P&Z STAFF REPORT

Case: **V-25-49 - 7821 Jett Ferry Road**
Staff Contact: Michele McIntosh-Ross (mmcintosh-ross@sandyspringsga.gov)
Report Date: December 28, 2025

Request for a Variance from Sec. 9.4.3.C., Sec. 9.4.2.G.2., Sec. 6.1.2.B., and Sec. 2.2.2 to allow a new house to encroach into the side setbacks, with walls, retaining walls, and grading.

SITE PLAN (received December 3, 2025)

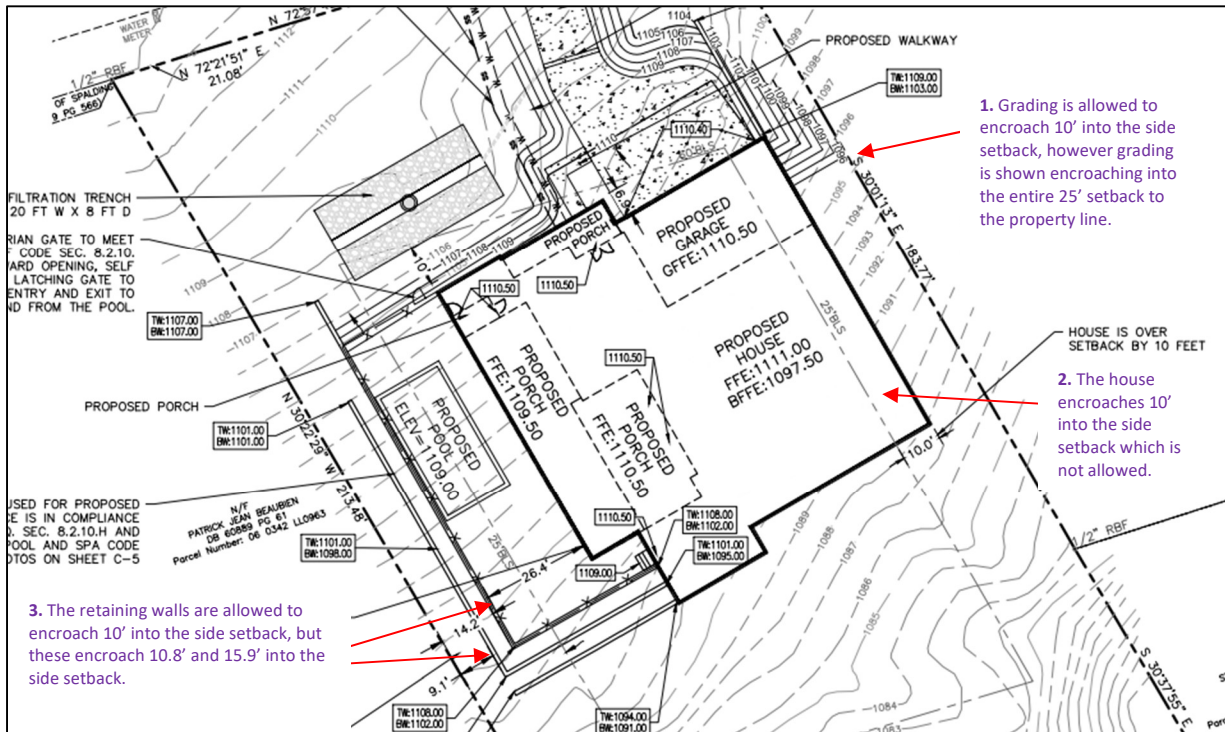
The proposed house plans show the following encroachments:

1. Variance to the eastern 25-foot side setback with grading (9.4.2.G.2.a) encroachments to the property line, 15 feet beyond what is allowed by Code.
2. Variance to the eastern 25-foot side setback with a house wall (6.1.2.B.) encroachment of 10 feet.
3. Variance to the western 25-foot side setback with retaining walls (9.4.3.C.1.a) and grading (9.4.2.G.2.a) encroachments 5.9 feet beyond what is allowed by Code.

The proposal shows grading encroachments 25 feet into the east side setback up to the common lot property line, and grading that encroaches more than 15.9 feet into the required side setback on the west side.

The proposal shows retaining walls that encroach 15.9 feet into the required side setback on the west side.

The proposal encroaches into the required side setbacks.

There are Boundary Trees visible on online aerial imagery on the eastern and western adjacent parcels that are not shown on the plan. The increased disturbance in the side setbacks from the proposed site plan could impact the Boundary Trees.

Retaining walls can encroach no more than 10 feet into the side setback. The site plan shows it almost 16 feet into the side setback (9.1 feet from the property line). The parcel can be better developed to allow the pool at the rear of the home and may be built in accordance with Code requirements. The water quality discharge location must be a minimum of 10 feet from the property line. Although related to planning and zoning, the garage appears to be more than 50% of the building façade (where 40% is the maximum). The garage also does not appear to be set back 5 feet from the front plain of the home’s conditioned space.

Proposed Development

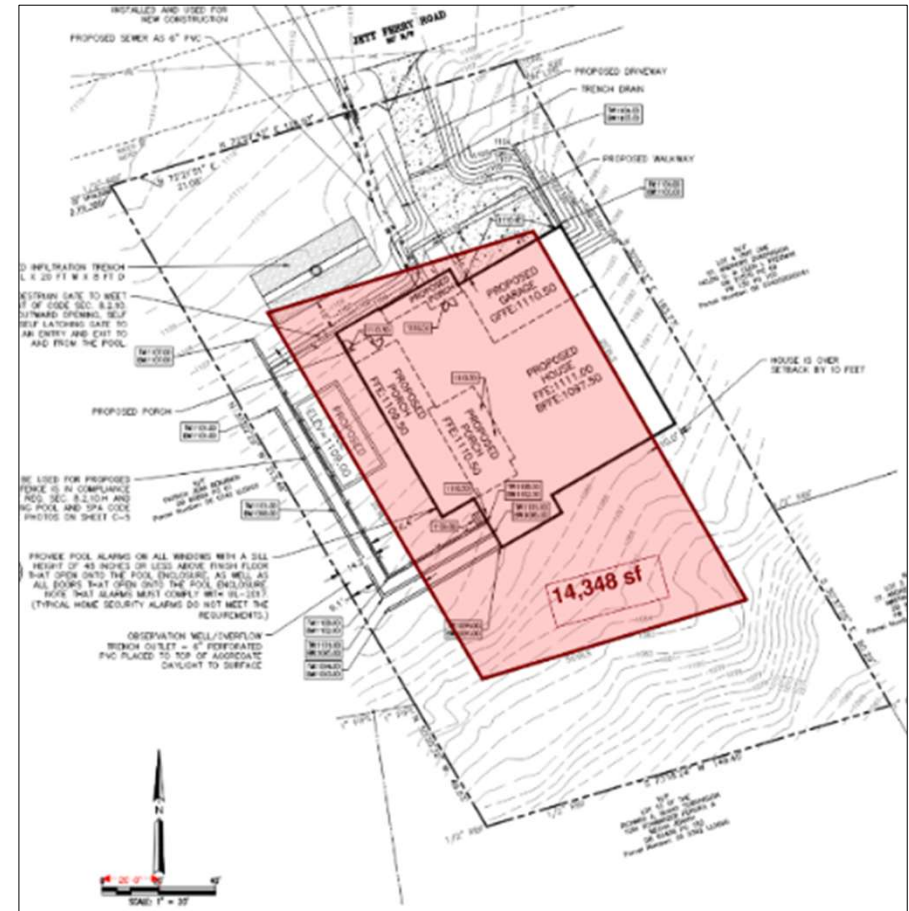
- The proposed house plan is a new 4,626 SF two-story house on vacant land
- Includes four bedrooms, four and a half bathrooms, two-car garage, three porches, an office, a pool and pool bath, and a basement
- The proposed house plans show the following encroachments:

1. East side grading encroaches to the property line (9.4.2.G.2.a)
2. East side house wall encroaches 10 feet into the side setback (6.1.2.B.)
3. West side retaining walls and grading encroaches 15.9 feet into the side setback (9.4.3.C.1.a) & (9.4.2.G.2.a)

- This lot is considered a nonconforming lot of record but is buildable with 14,348 SF of buildable area (pink box to the right).
- Retaining walls and grading can encroach up to ten (10) feet into the 25' side setbacks, and can encroach up to 30 feet into the 50' rear setback.
- Swimming pools can also encroach into the side and rear setbacks a minimum of 10 feet from the property line, or within grading and retaining wall setbacks.
- A differently designed house plan could meet the allowances of this Development Code.
